32 W. KIRKE 35/13-07U

HISTORIC PRESERVATION COMMISSION STAFF REPORT

Address:	32 West Kirke Street, Chevy Chase	Meeting Date:	6/13/2007
Resource:	Contributing Resource Chevy Chase Village Historic District	Report Date:	6/06/2007
Review:	HAWP	Public Notice:	5/30/2007
Case Number:	35/13-07U		
Applicant:	Mr. and Mrs. Lynham (David Jones, AIA)	Tax Credit:	None
		Staff:	Michele Oaks
Proposal:	Major Addition and Alterations

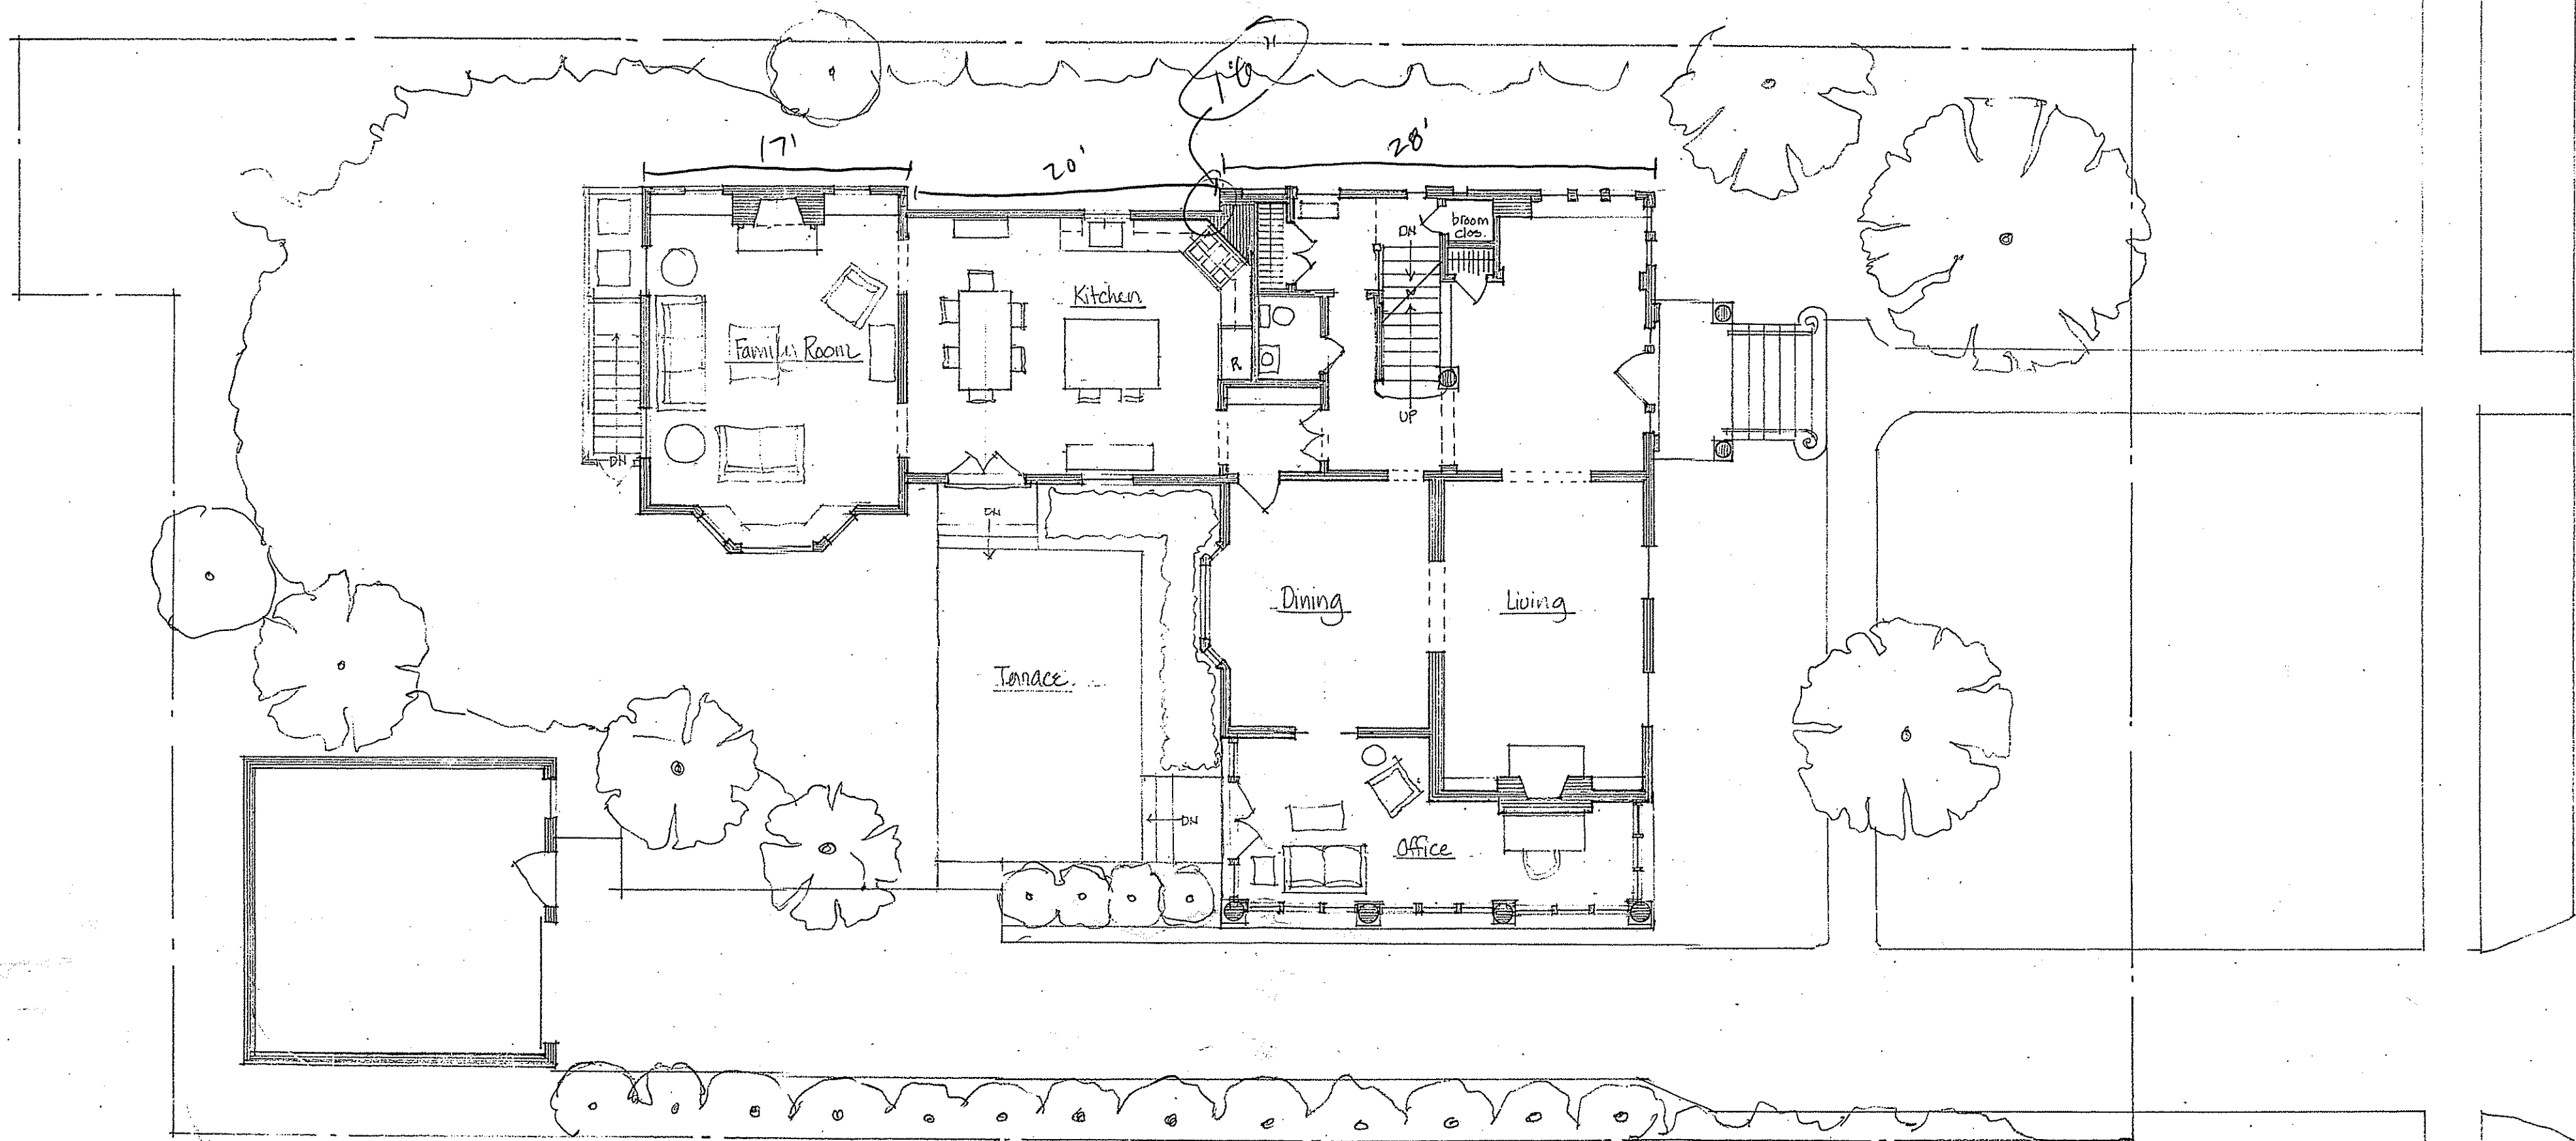
Also, what are the other materials you are proposing? wood lap siding? stone foundation? I can't really tell from the drawings. If so, I would support this direction. Hardi-siding is approvable, but it must be trimmed out in wood. All the other details, porch railings cornices etc also must be wood. Chimney material should be stone or brick, not a stucco or lap siding.

1. Lower roofline
2. Continuity in design, addition with the original massing
